**RE: ENGINEER'S CERTIFICATION FOR OFFICE/WAREHOUSE (C-17/D19)  
RECEIVED JAN 19, 1999 FOR CERTIFICATE OF OCCUPANCY  
ENGINEER'S STAMP DATED 1/18/99**

**RE: OFFICE - WAREHOUSE (C17-D19). GRADING AND DRAINAGE PLAN FOR BUILDING  
AND GRADING PERMIT APPROVALS. ENGINEER'S STAMP DATED 1-7-98.**

Re: Bradbury Stamm Construction Headquarters, Engineer's Stamp dated 7-28-06  
Tract F2 of the Lands of Springer Building Materials Corporation (C17/D19)

**Re: OGB Architectural Millwork TI and Improvement 3711 Paseo Del Norte  
Grading and Drainage Plan  
Engineer's Stamp dated 1/23/07 (C17/D019)**

## CULVERT CALCULATIONS

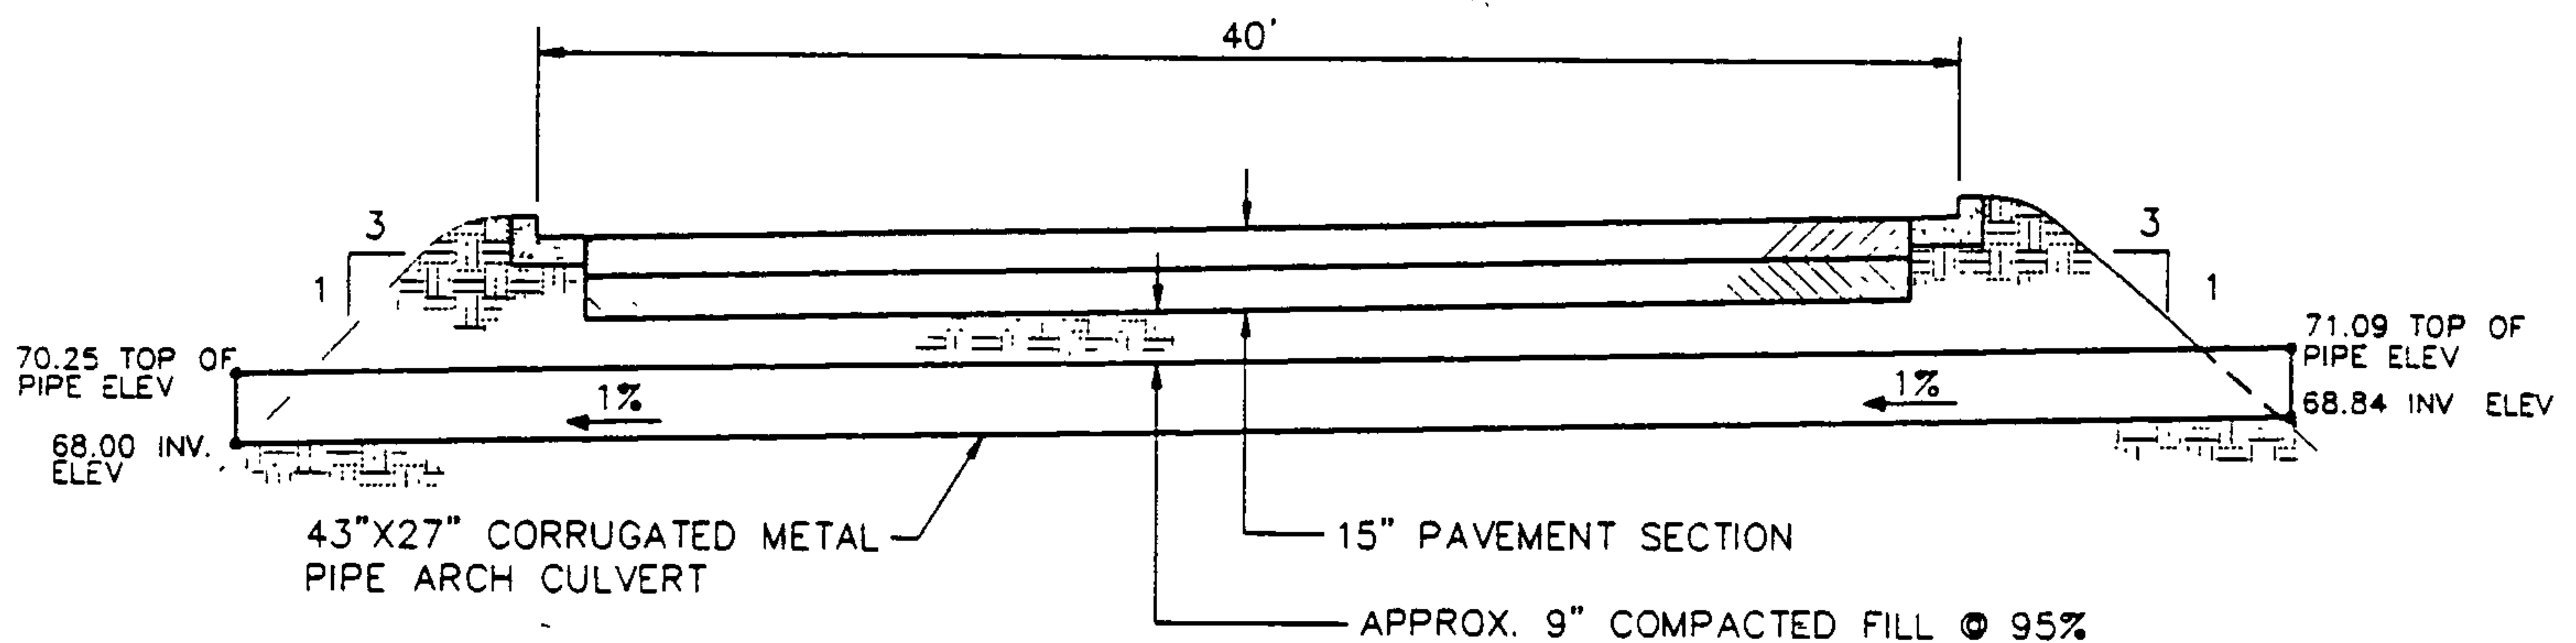
I found some calcs for the 43"x27" cmp. They did not assume any pressure flow, just did a Manning's on it and came up with 33.48 cfs.

SECTION E  
N.T.S.

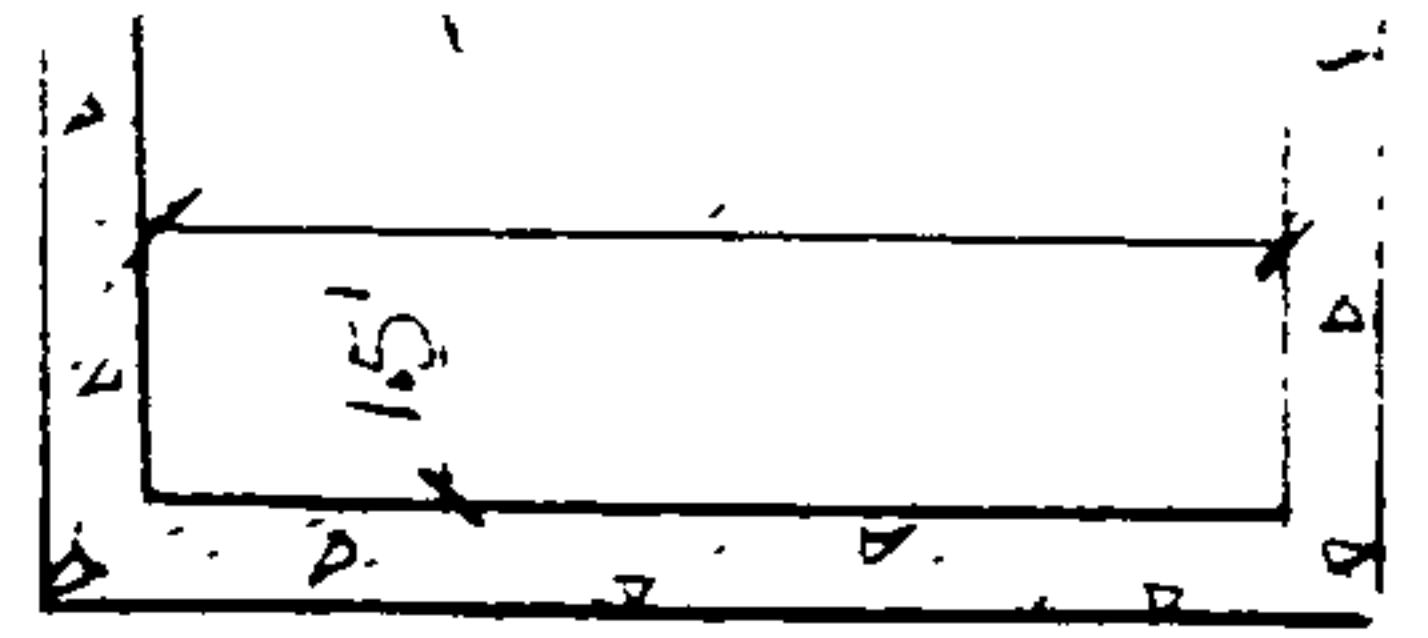
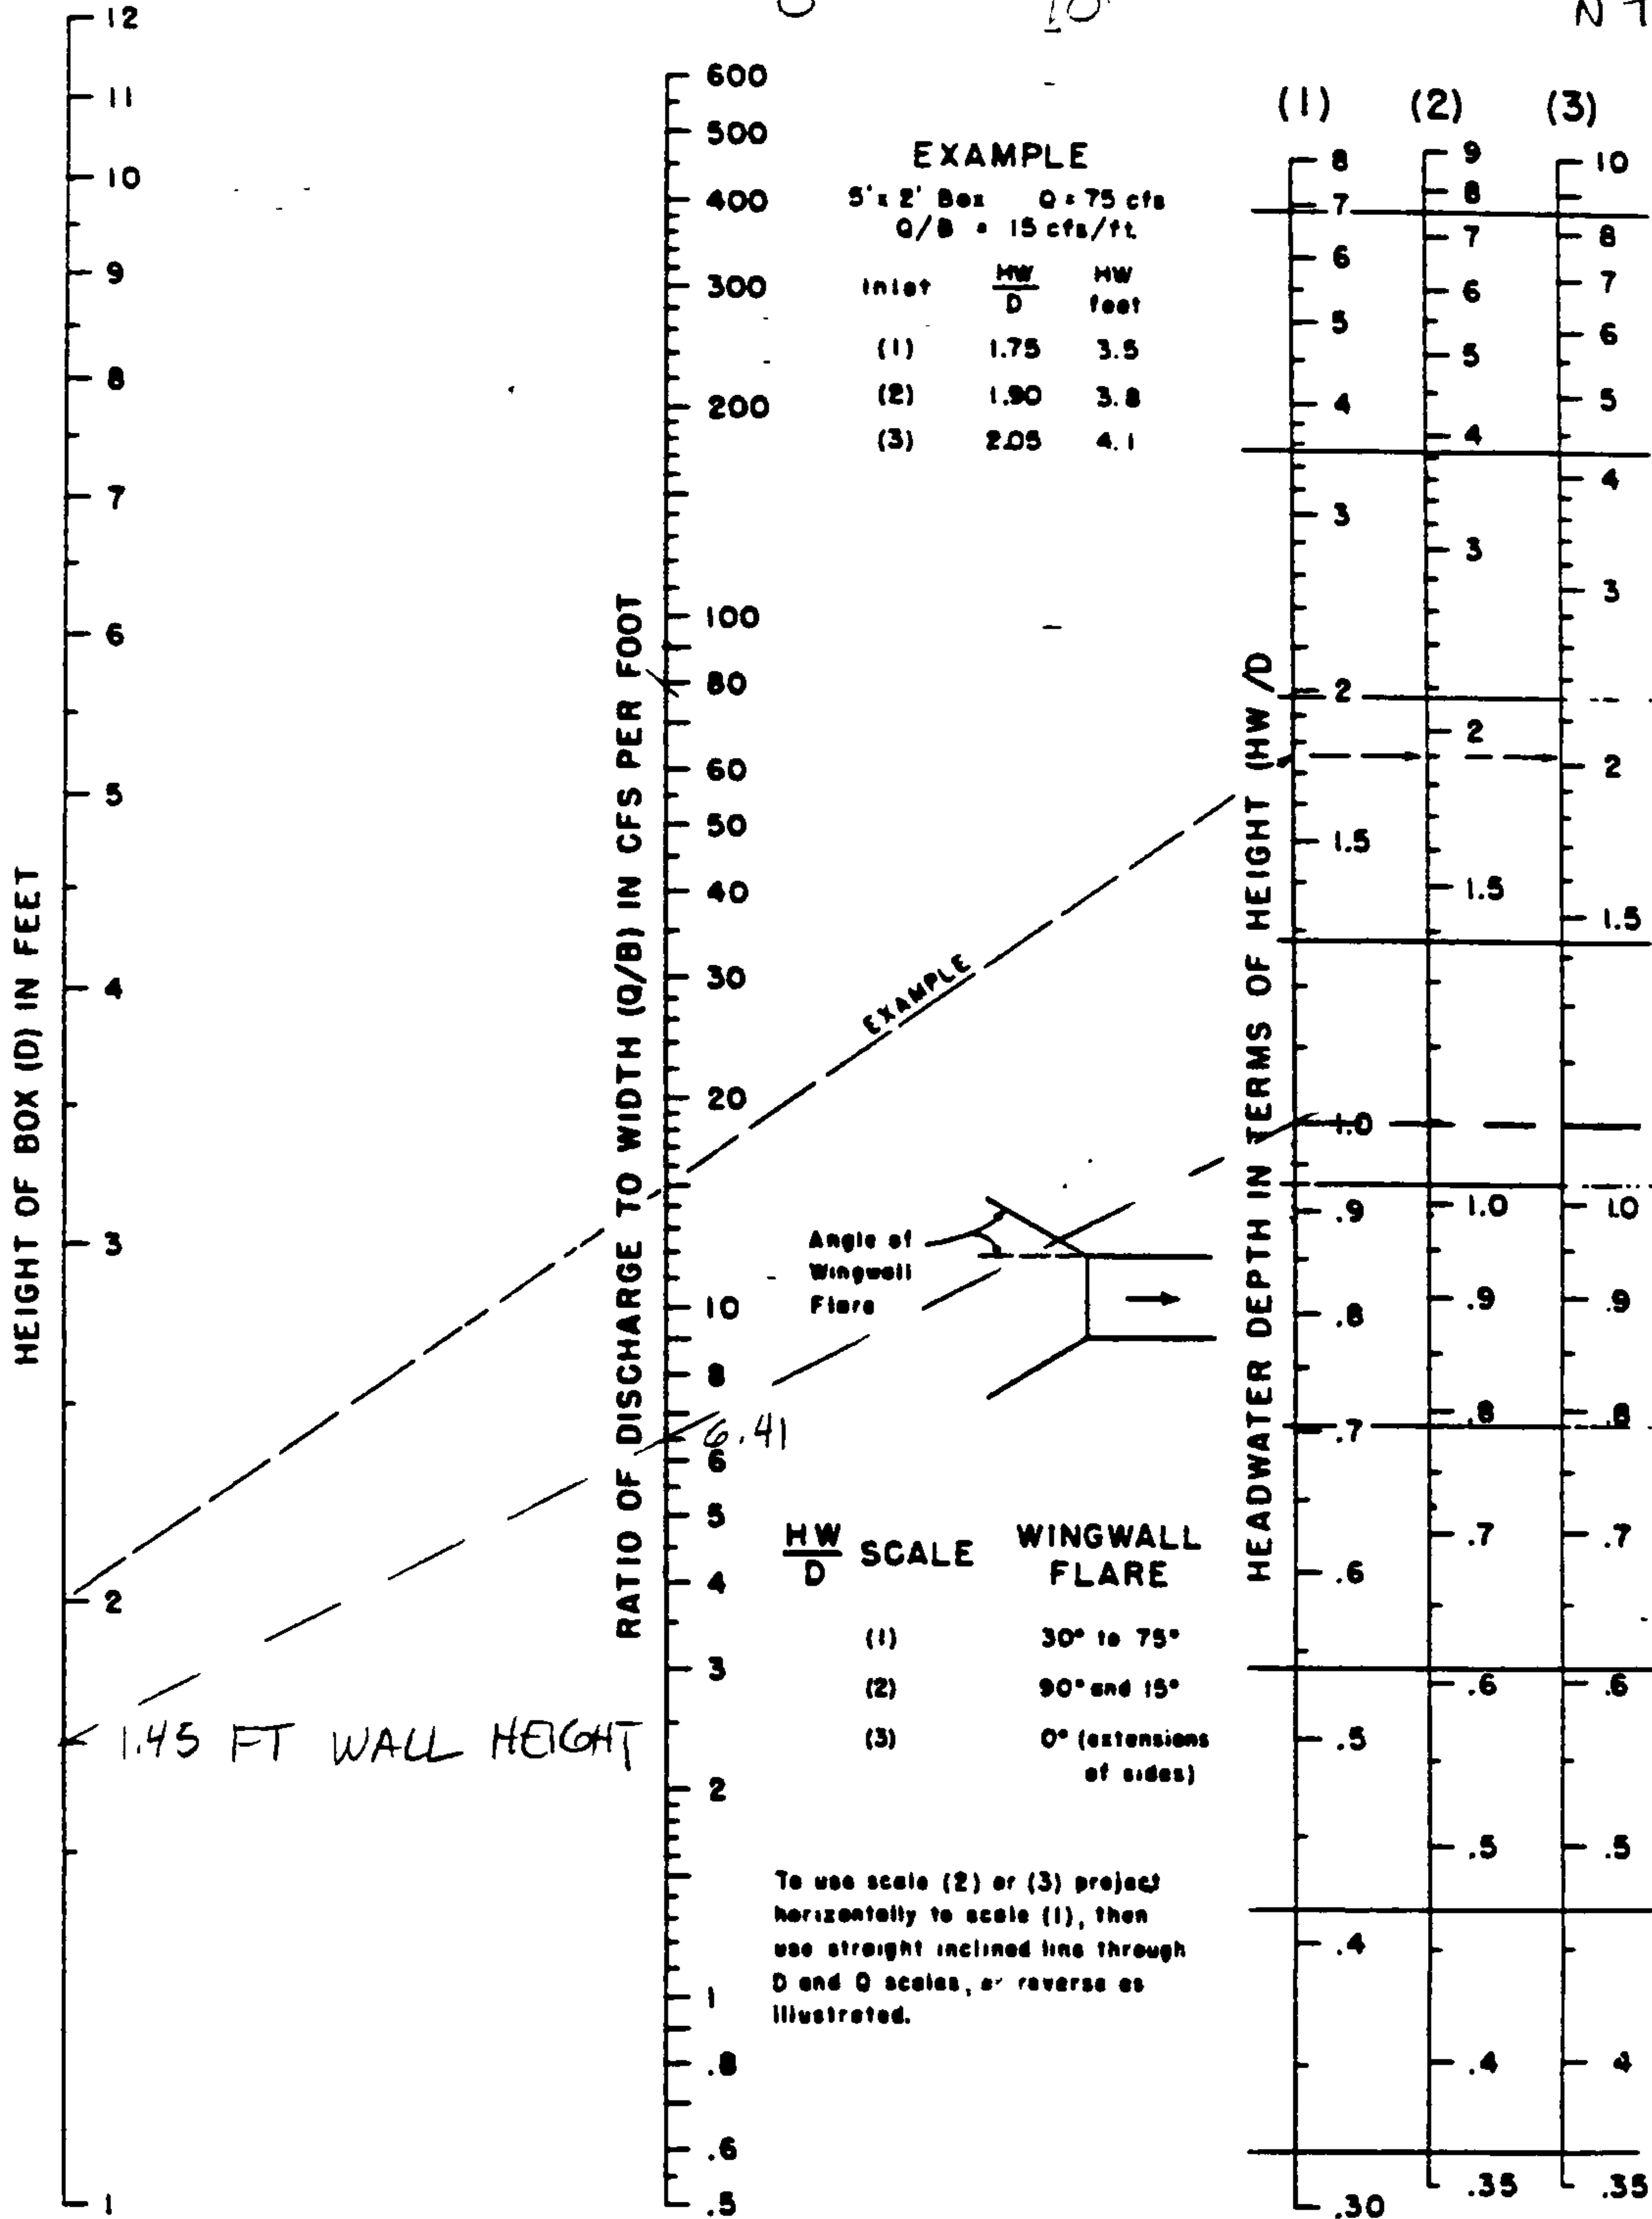
$$\frac{Q}{B} = \frac{34.1 \text{ CFS}}{10'} = 3.41$$

1.5 FT WALL HEIGHT ACCOMMODATES FLOW OF 34.10 CFS IN THE 10' WIDE NECK.
